UNITED STATES PATENT AND TRADEMARK OFFICE

APPLICATION NO.	FILING DATE	FIRST NAMED INVENTOR	ATTORNEY DOCKET NO.	CONFIRMATION NO.
10/607,177	06/25/2003	Dallas B. Wynne	10739.18.66	5200

Office Action Summary

DETAILED ACTION

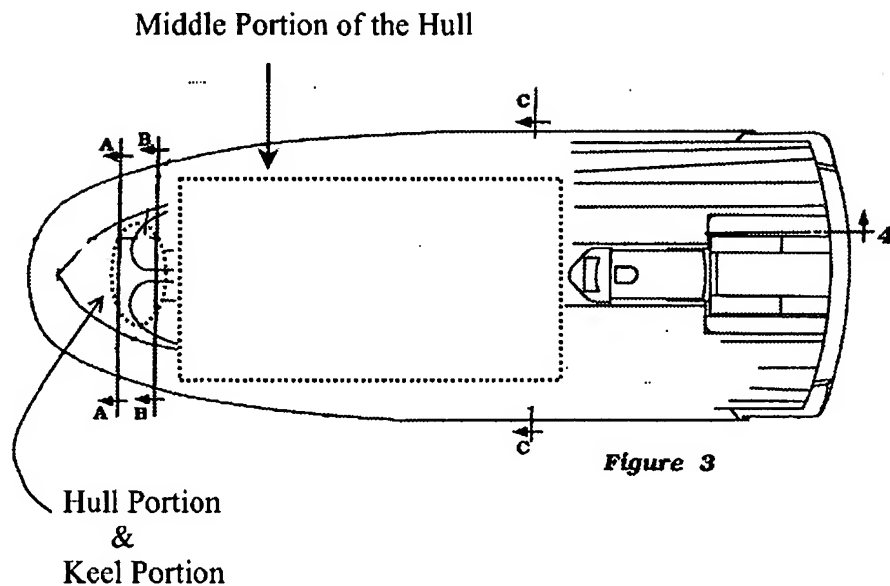
3. Claims 1, 2, 4-9, 11, 12, 17-20, 25, 26, and 31 are rejected under 35 U.S.C. 102(b) as being anticipated by Hattori et al. (US 5,390,621 A).

Hattori et al. ('621) shows a personal watercraft with a hull, and a small hull portion in a forward location of the hull, as shown below between section lines A and B. A keel portion [27] extends the length of the hull portion, as shown by dotted lines below. The keel section has concave hull sections disposed on each side of the keel section. A middle of the hull is defined by an area that is disposed substantially between the section lines B and C, as shown below with a dotted rectangular area.

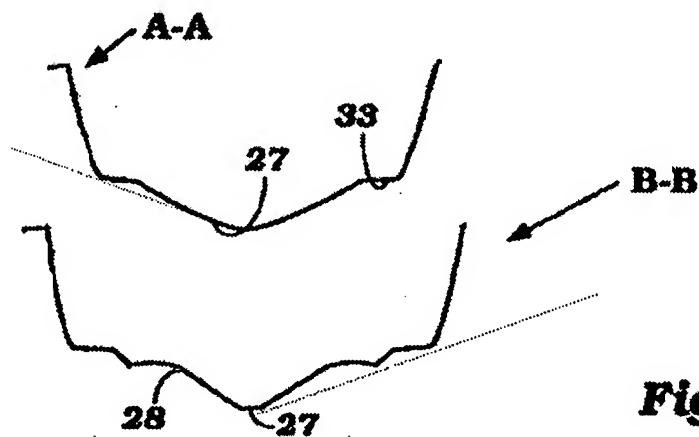
A keel angle, defined by the angle formed between the two opposing keel surfaces, is smaller at the rear part of the keel portion than at the front part of the keel portion (see [figures 3 and 5](#)). Similarly, the slope of keel opposing walls increases from front to the rear portion of the keel. The concave hull sections disposed on each side of the keel define the respective keel troughs, which increase in depth from front to the rear of the watercraft.

Re claims 4-7, the hull appears to be a standard sized hull, and therefore the keel appears to begin within about 3.5 feet forward of the rear most extent of the watercraft, which therefore is also within four feet and five feet forward of the rear most extent. Similarly, the front limit appears to be located at least 2 feet, and therefore at least five feet, forward of the keel rear limit. Applicant may note that the limitation "about" has been broadly interpreted to mean "in the vicinity of". When considered with respect to an extremely sizeable length (e.g., a length of 500 feet), even a length of 6-7 feet, or a length of 3-4 feet, can be considered to be "about five feet."

Re claims 11 and 12, the keel portion lies within a 10 percent length on a front side of the middle portion of the hull, and is therefore also within a 15 percent length.
